**Re: Environmental Stewardship Comments on GMA-12 Proposed Desired Future Conditions**

# Proposed Desired Future Condition(s) for Aquifer(s) in GMA 12

## Environmental Stewardship

Figure 1. Predicted reduction of discharge of groundwater into the mainstream Colorado River due to combined pumping (Old GAM).

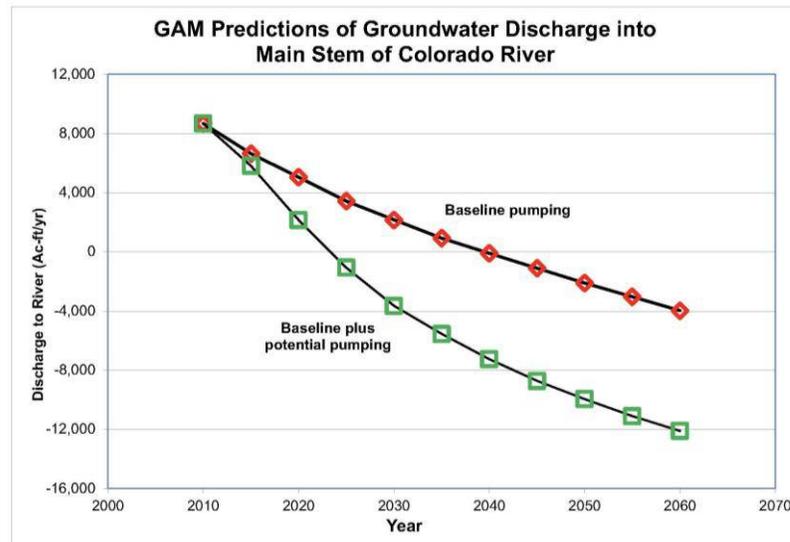
- The Old GAM predicted that baseline pumping will:
  - Reduce discharge to the main stem of the Colorado River by about 13,000 ac-ft per year from 2010 to 2060.

- Reverse its historical relationship to the aquifers by changing from a stream that *gains* water from the aquifers (a gaining stream) to a stream that *loses* water to the aquifers (a losing stream) in about 2040.

- The Old GAM predicted that potential pumping by Vista Ridge, End Op (now Recharge Water) Forestar and LCRA power plant will:
  - Reduce discharge to the main stem of the Colorado River by about 22,000 ac-ft per year from 2010 to 2060.

- Reverse its historical relationship to the aquifers by changing from a stream that *gains* water from the aquifers (a gaining stream) to a stream that *loses* water to the aquifers (a losing stream) about 20 years earlier (2020) than baseline pumping.

Figure 2. Predicted reduction of discharge of groundwater into the mainstream Colorado River due to DFC Run 3 and Scenario S-7 (New GAM).

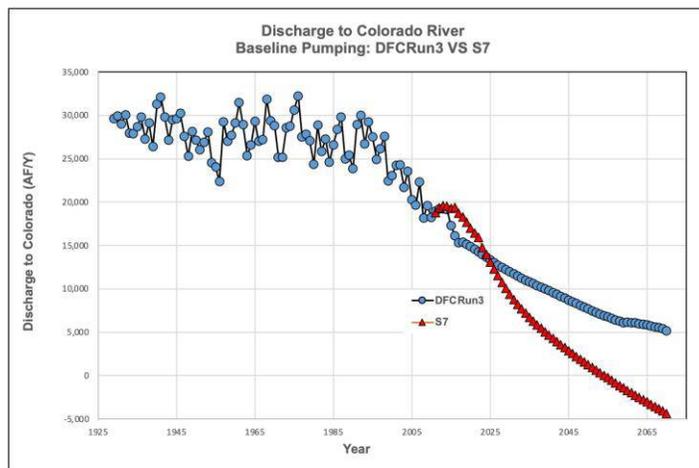
As seen in Figure 2, the New GAM reflected a reduction in outflows to the main stem of the rivers started with the development period in 1990. During the early development period from 1990 to 2010, outflows to the river declined by about 30,000 acre-feet per year.

- The New GAM (DFC Run 3) predicts that pumping will:
  - Reduce discharge to the main stem of the Colorado River by about 14,000 ac-ft per year from 2010 to 2070.

- The New GAM (S-7) predicts that pumping will:
  - Reduce discharge to the main stem of the Colorado River by about 24,000 ac-ft per year from 2010 to 2070.

- Reverse its historical relationship to the aquifers by changing from a stream that *gains* water from the aquifers (a gaining stream) to a stream that *loses* water to the aquifers (a losing stream) by about 2050.

- By comparison:
  - The new GAM predicts that Scenario S-7 will reduce outflows by about 10,000 ac-ft per year more than DFC Run 3.
  - The new GAM predicts that Scenario S-7 will cause a reversal in the surface water-groundwater relationship to occur about 2050 whereas DFC Run 3 does not predict a reversal within the planning period.

Figure 3: Groundwater Discharge to four tributaries of the Colorado River located primarily in Bastrop County, TX (New GAM).

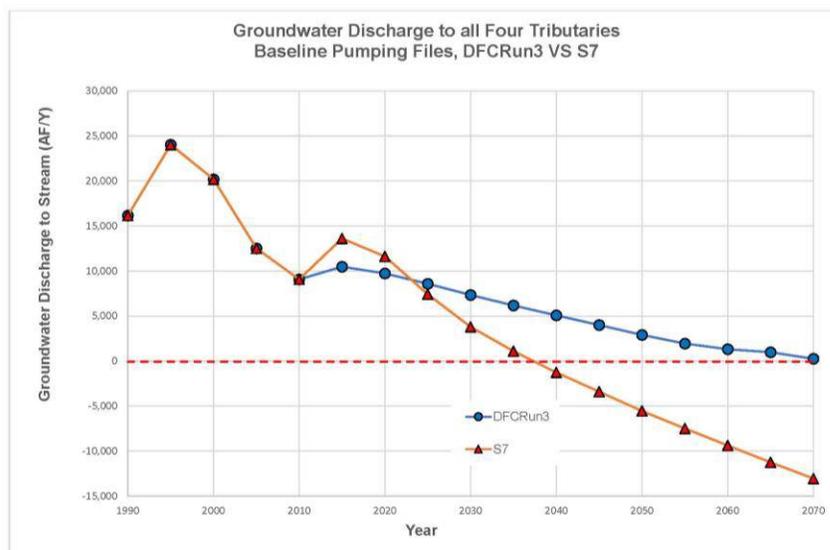
The new GAM predicts (Figure 3) that combined flows of the four tributaries:

- Have had historic outflows that were significantly higher than are predicted during development,
  - outflows declined during the early development period; and
  - outflows are predicted to continue to decline as pumping increases in the current development period.
- Will reverse their relationship with the aquifers by contributing surface waters to the aquifers (losing streams) during the planning period.
  - S-7 pumping will accelerate the reversal by several decades.

Figure 4. Groundwater Discharge to Wilbarger, Big Sandy, Walnut/Cedar and Piney Creeks/Lake Bastrop, Bastrop County, TX (New GAM).

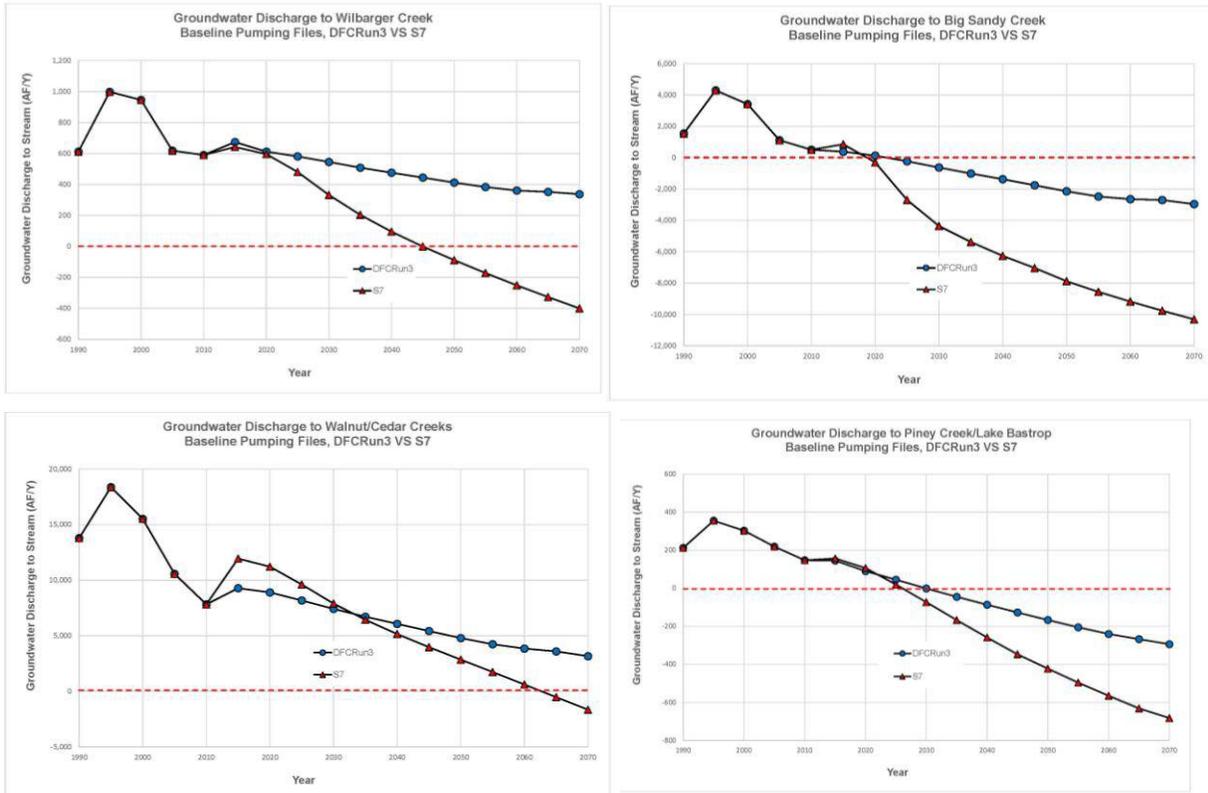
Wilbarger Creek: Overall, S-7 pumping caused a greater decline in outflows from the aquifers than DFC Run 3. Likewise, S-7 pumping is predicted to cause a reversal in the surface water-groundwater relationship whereas DFC Run 3 does not predict a reversal. Wilbarger Creek flows across the outcrops of the Hooper, and the Simsboro.

Big Sandy Creek: Overall, S-7 pumping caused a greater decline in outflows from the aquifers than DFC Run 3. Both DFC Run 3 and S-7 pumping predict a reversal in the surface water-groundwater relationship has already occurred. Big Sandy Creek flows across the outcrops of the Hooper, Simsboro, and Calvert Bluff.

Walnut/Cedar Creek: Overall, S-7 pumping caused a greater decline in outflows from the aquifers. Likewise, S-7 pumping is predicted to cause a reversal in the surface water-groundwater relationship whereas DFC Run 3 does not predict a reversal. Walnut/Cedar flows across the outcrops of the Hooper, Simsboro, Calvert Bluff, and Carrizo.

Piney Creek/Lake Bastrop: Overall, S-7 pumping caused a greater decline in outflows from the aquifers. Both S-7 pumping and DFC Run 3 are predicted to cause a reversal in the surface water-groundwater relationship. Piney Creek/Lake Bastrop flows across the outcrops of the Calvert Bluff and Carrizo.

Figure 6. Wilbarger creek Interaction with Aquifer, All Nodes 1990, 2020, 2050 and 2070 (New GAM).

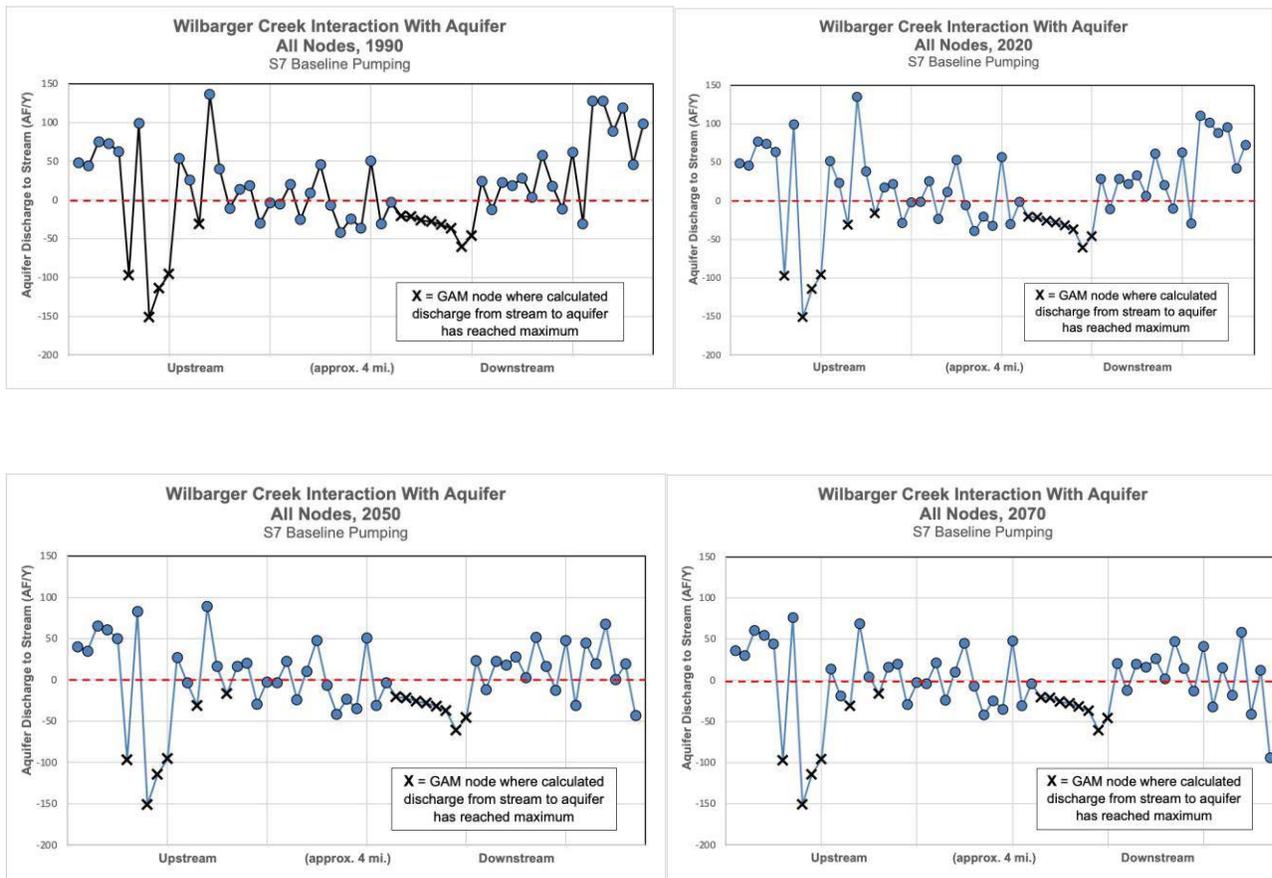
The maximum discharge rate from Wilbarger Creek to the aquifers<sup>11</sup> occur at 14 nodes. These nodes are listed in Appendix 1. At 13 of the nodes the maximum rate is already occurring by the year 1990. This is because the head in the underlying aquifer is already below the bottom of the streambed. The exception is node 4615 (layer 2 Hooper) which begins discharging at the maximum rate by 2020.

The other finding from this analysis occurs in the last six nodes nearest the confluence of Wilbarger Creek with the Colorado River. There is a strong trend for outflows in this segment of the stream to decline from a high of 150 ac-ft per year in 1990 (a gaining stream) to a low of minus 100 ac-ft per year in 2070 (a losing stream).

From this analysis, one of the places where the GAM short-comings have an impact becomes evident; in this case on tributary streams. With the understanding that this is a calculation of limited maximum discharge, it is reasonable to conclude that there is a level of uncertainty related to the GAM predictions that should be noted. Field studies would be the only means of confirming the situation and provide empirical data to update the GAM.

Figure 8. Colorado River at Bastrop gage during drought period Jan. 2011 - Dec. 2013. A hydrograph separation is requested for the period.

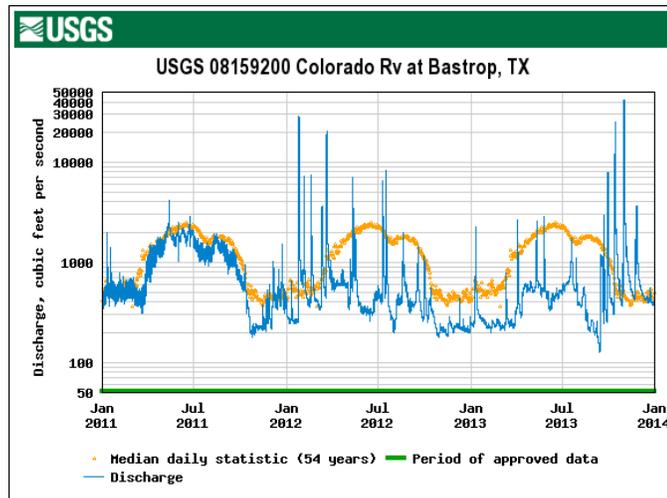
Figure 8 is a hydrograph of the three year drought period from January 2011 through December 2013 when the region experienced some of the most severe drought conditions in decades. The distinguishing feature of this figure is that in-stream flows benefitted from the irrigation releases for down-stream rice farming during the spring, summer and early fall of 2011 and then was curtailed during the 2012 and 2013 irrigation seasons. There was very little flow from rainfall during the 2011 period. Lacking irrigation flows, flow in the river for the summer and fall would likely have dropped below the subsistence environmental flow range during that period. The health of aquatic communities in the Colorado River cannot be dependent on such calls by downstream water rights holders, demonstrating the need to protect and preserve groundwater inflows to the maximum degree possible.

A hydrograph separation on the three year period represented in Figure 8, with irrigation releases and return-flows accounted for, would likely reveal a very good estimate of actual groundwater outflows to the river from the Carrizo-Wilcox Aquifer group. During this period the bank storage for the river had likely been exhausted and the river was relying on the minimum flows passing through the Austin gage at Longhorn Dam, City of Austin, Pflugerville and Elgin return flows, and groundwater baseflows.

Groundwater hydrograph Separation segregates hydrograph into groundwater discharge and runoff

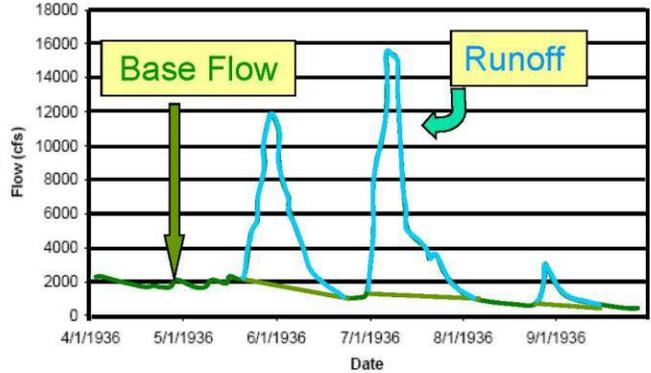
Slide 27 of the GMA Consultant Team's presentation (Appendix 6) discussed hydrograph separation of river gage data to separate a hydrograph into groundwater discharge and runoff. Using this methodology, it is possible to get an estimate of the groundwater contribution to stream flow, known in surface water hydrology as "baseflow". Hydrograph separation methodology and applications are discussed in further detail in the recent publication: Surface water-groundwater interaction issues in Texas.<sup>21</sup>
